# TECHNICAL NOTE

To: Oxfordshire County Council – LLFA  
 Cc: Charlie Merry (DWD); Serena Page (DWD); Kerry Bidwell (Lysander); Charlie Shanks (Lysander);  
 File  
 From: EirEng Consulting Engineers  
 Date: 23/02/2022  
 Project Title: Banbury 200, Southam Road, Banbury OX16 2FW  
 Project No: 212088  
 Re: Planning Application 21/04157/F – LLFA Response

This Technical Note has been prepared to respond to LLFA Detailed Comments relating to Planning Application 21/04157/F and is included in Appendix A. This provides further information with reference to previously submitted documents and drawings, with supplementary documents and drawings prepared as part of this response.

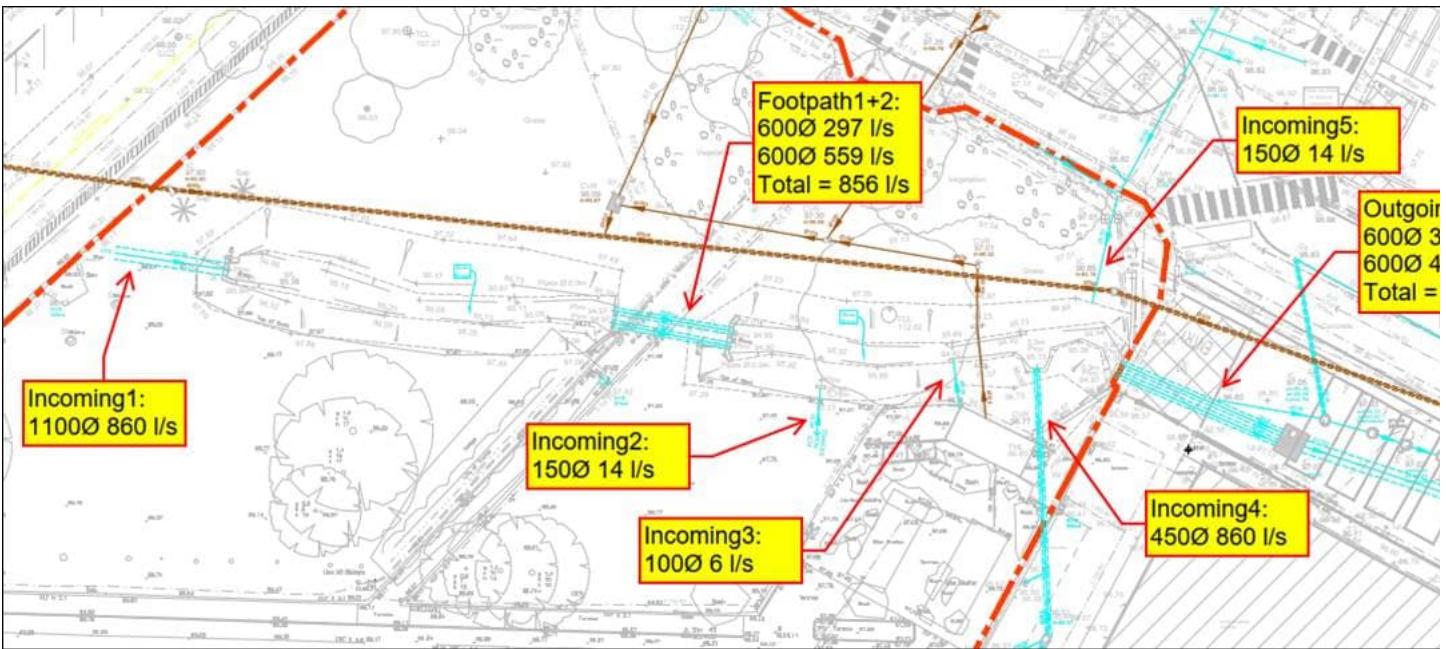
I would like to understand what the existing watercourse currently is taking (Topo shows incoming pipes), and how the additional surface water loads impacts the watercourse. I appreciate the fact the surface water discharge is reduced significantly, however as there is still an increase in surface water loads compared to its previous state it can pose flooding risk.

If discharge is to an ordinary watercourse, evidence will need to be provided to ensure that the system can accept the proposed flows to an acceptable downstream point without increasing risk to others.

Firstly, we have determined the pipe full capacities of all known incoming and outgoing pipes at the ditch, based on currently available level and diameter information. The results are summarised as follows together with accompanying extract showing locations:

The ditch has also been assessed and it seems reasonable it has been designed to attenuate the incoming flows prior to discharge from the site. We have provided a revised existing site plan with sections through the ditch which shows there is a significant element of local storage. With the reduction in flows into the ditch being reduced by as much as 95%, there will be greater storage availability prior to discharge from the site. The outgoing flows from the ditch are then conveyed by a culverted system beyond the site boundary for several kilometres downstream before it discharges to the River Cherwell.

With reference to the 'ordinary watercourse', this was taken from the Flood Risk Assessment submitted with this planning application. From further inspection, the incoming flows to the ditch are from a catchment area to the west of the site which is under Thames Water ownership from review of their record maps (attached for reference). The outgoing pipe then conveys to a 1275mm diameter pipe beyond the east of the site along Southam Road, which then adjoins a pipe that then continues to be under Thames Water ownership and increases in pipe diameter further downstream. The 1275mm diameter pipe has been assessed as having a pipe full capacity of 5688 l/s (based on Thames Water records).
